SIB 51 07 25
TRUNK LID TRIM PANEL LOOSE

2025-04-17

E-Series	Model Description
G23	4 Series Convertible
G83	M4 Convertible

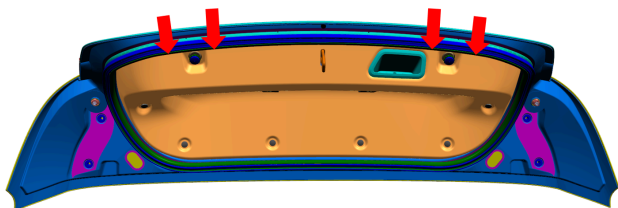
The trunk lid trim panel may partially come loose/dangle (red arrows show the most prevalent areas).

Unfavorable tolerance of the mounting clips that secure the trim panel to the trunk lid.

Replace the three clips that secure the trim panel to the trunk lid with the new updated clips.
